<b>Docket Number:</b>	09-AFC-08C
<b>Project Title:</b>	Genesis Solar Energy Project
<b>TN #:</b>	266933
<b>Document Title:</b>	09-AFC-08C Genesis Solar Petition to amend-Hydrogen removal equipment rev 01
<b>Description:</b>	N/A
<b>Filer:</b>	Cynthia Keller
<b>Organization:</b>	NexteraEnergy Resources
<b>Submitter Role:</b>	Applicant
<b>Submission Date:</b>	10/30/2025 1:09:18 PM
<b>Docketed Date:</b>	10/30/2025

# **Genesis Solar, LLC**

## **Petition to Amend - Revision 1**

**Revised 10/17/2025**

*Figure 1: Proposed HyMATE system location in the Genesis power blocks*

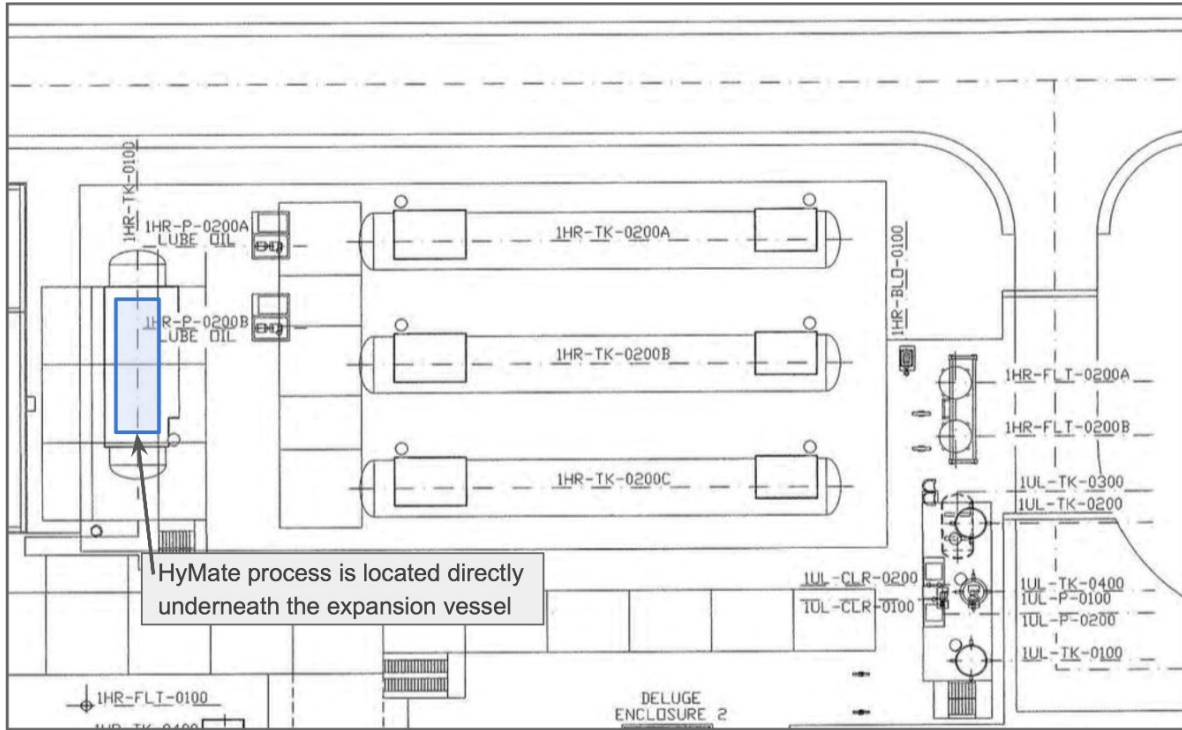
The location of the HyMATE process is shown in Figure 1 and is directly under the EV. This area (Figures 2, 3) is covered with a concrete pad, has close proximity to the EV, and has ample height and width clearance. These features make this location best suited for installation of the HyMATE process. The location is accessible from the adjacent paved road. The HyMATE process will be unloaded from a flatbed truck and positioned onto the concrete pad using a forklift or crane.

Figure 4: Schematic of piping runs between EV and HyMATE process

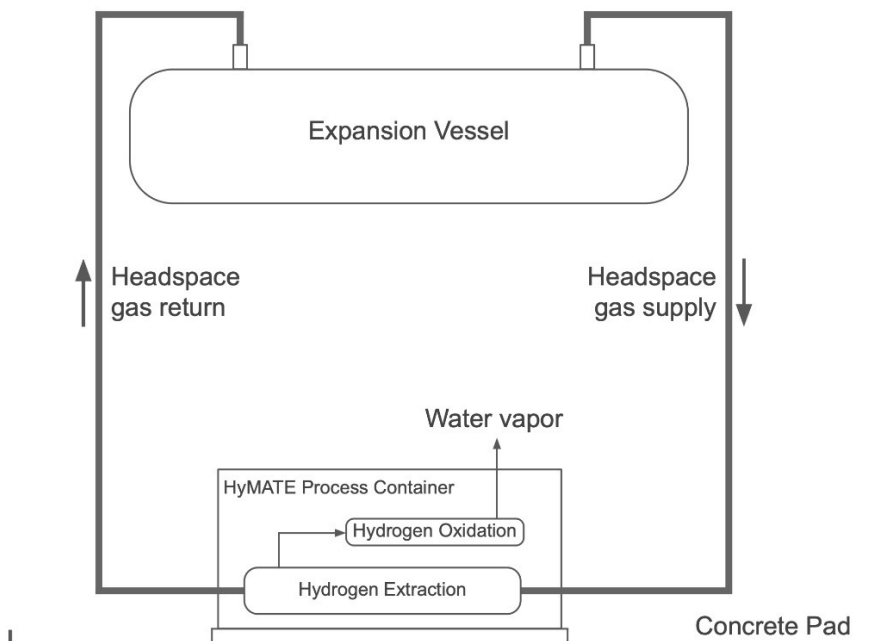
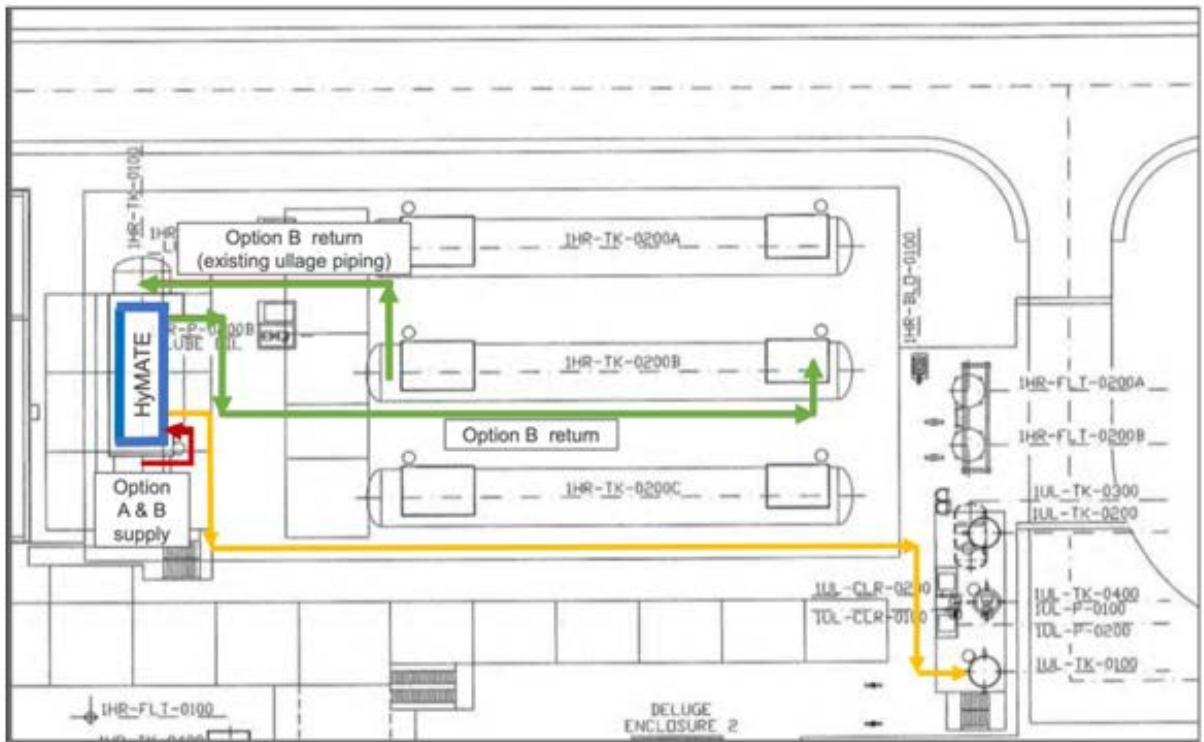
- 6" Return to Expansion through overflow vessel
- 6" supply from Expansion Vessel HyMATE Unit
- 1" HTF condensate to Ullage Vessel #1
